GRAVITY WALL SECTION A - A
(WALL 1 SECTION SHOWN AT STA 19')

Vermont Agency of Transportation
Accepted as Noted
By Rob at 8:24 am, Apr 12, 2017

Designed By: JBC	Project: HUNTINGTON BF 0211 (32) HUNTINGTON, VERMONT	Registration No: 8619
Scale: 1"=5'	Title: SECTION A - A	Project No: 16-1034
Date: JAN 10, 2017		Sheet No: 5.00

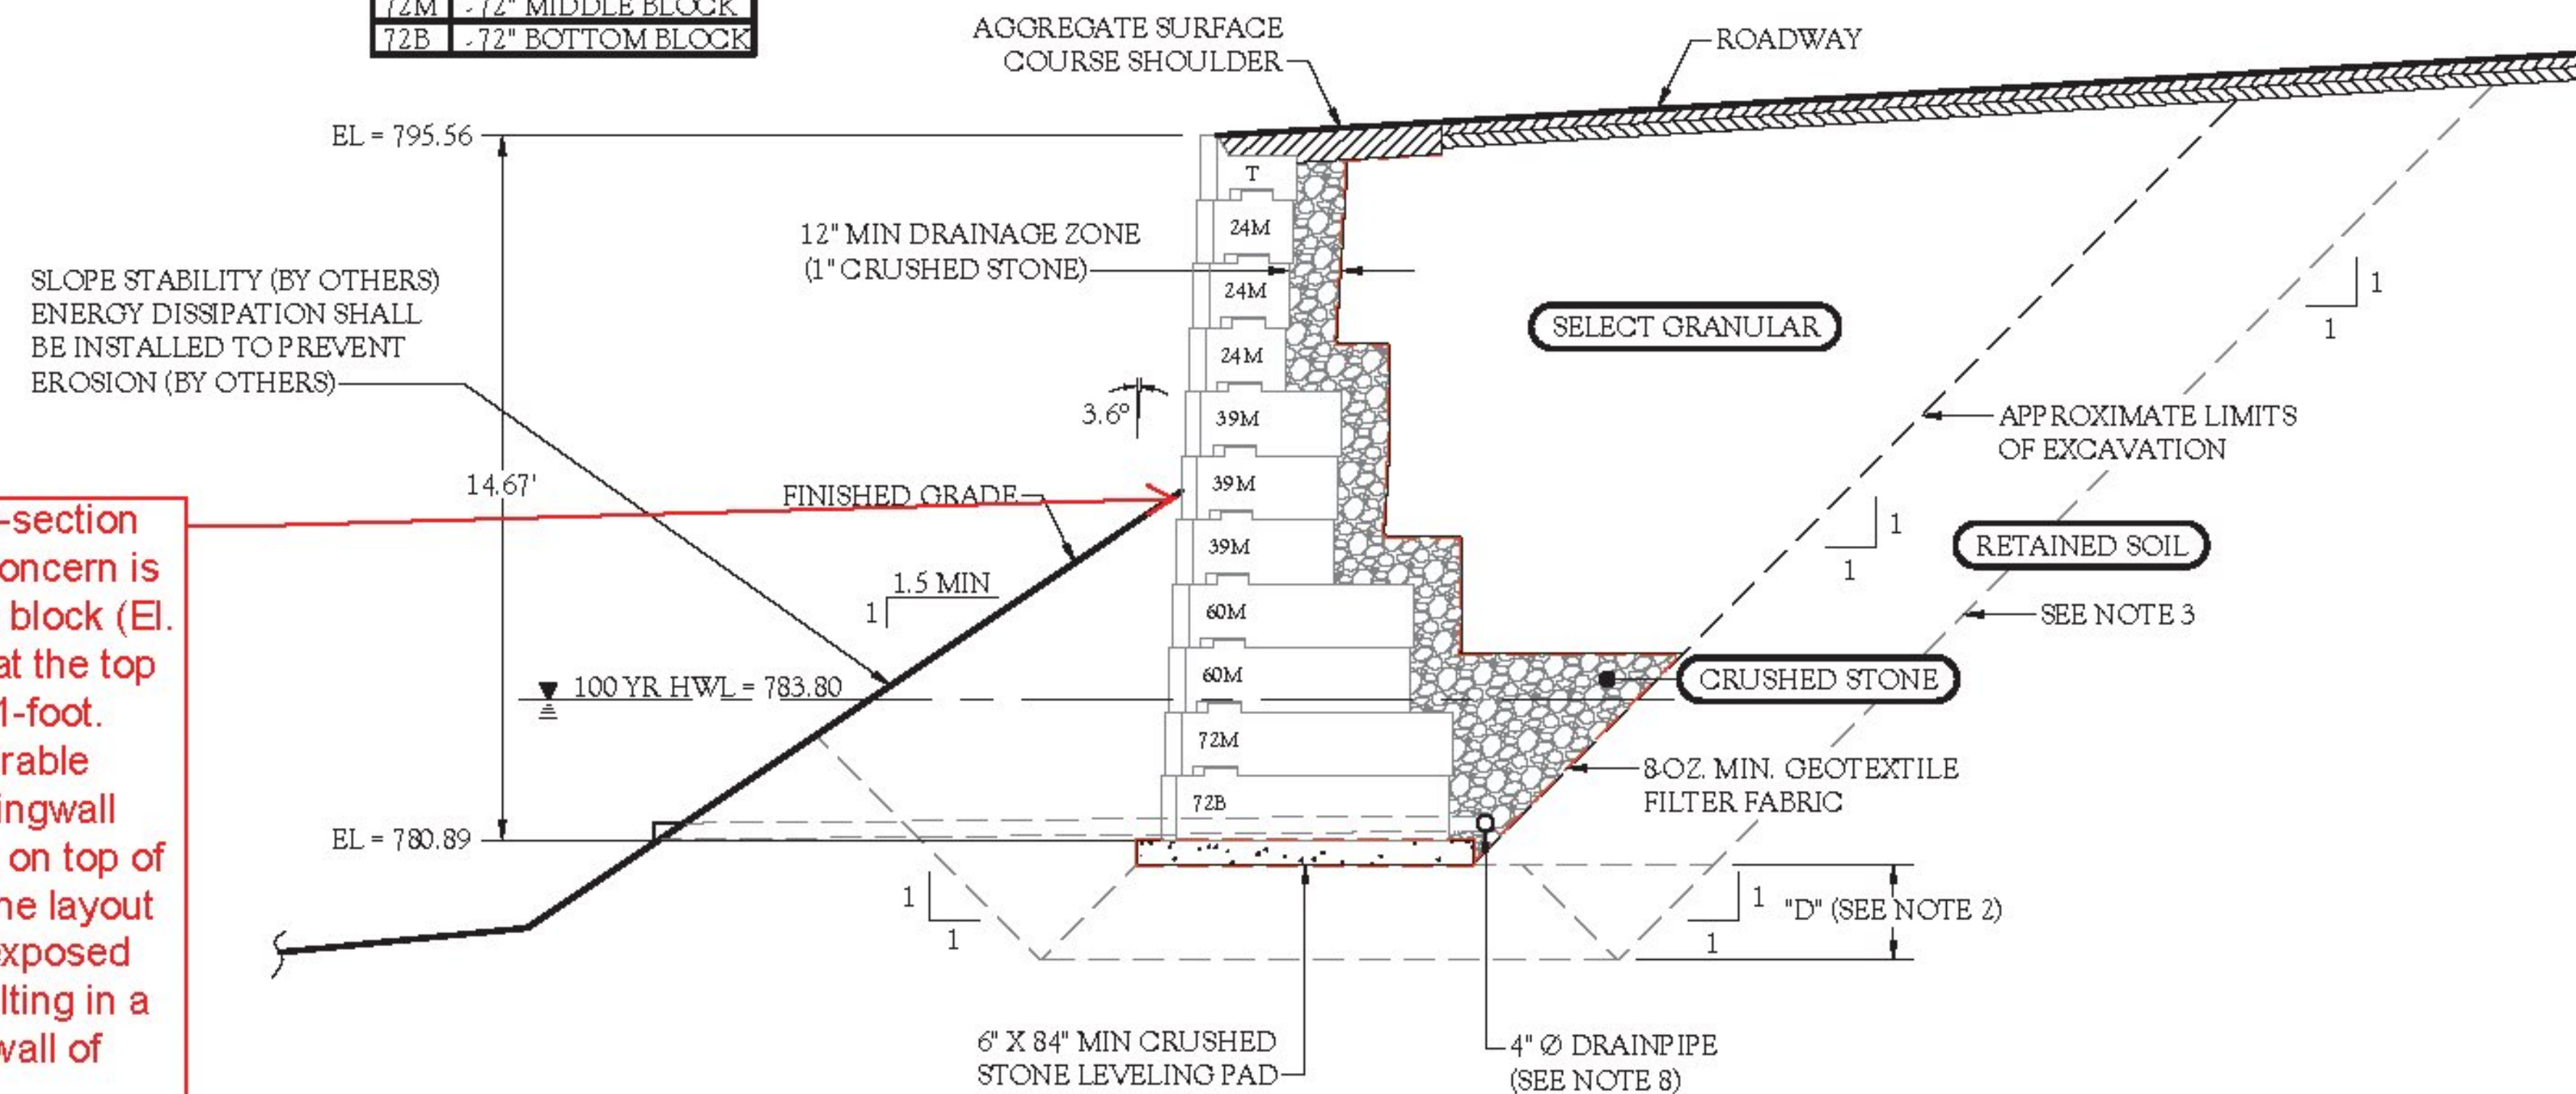
Please indicate where on the cross-section the wall layout will be based. The concern is if the layout is based on the bottom block (El. 780.89), the relative displacement at the top of wall due to the batter is approx. 1-foot. This displacement would be undesirable where this wall abuts the vertical wingwall and it would produce a steep slope on top of the wall, at the beginning of wall. The layout should be based on the minimum exposed elevation (Approx. el. 786.85), resulting in a relative displacement at the top of wall of approx. 6".
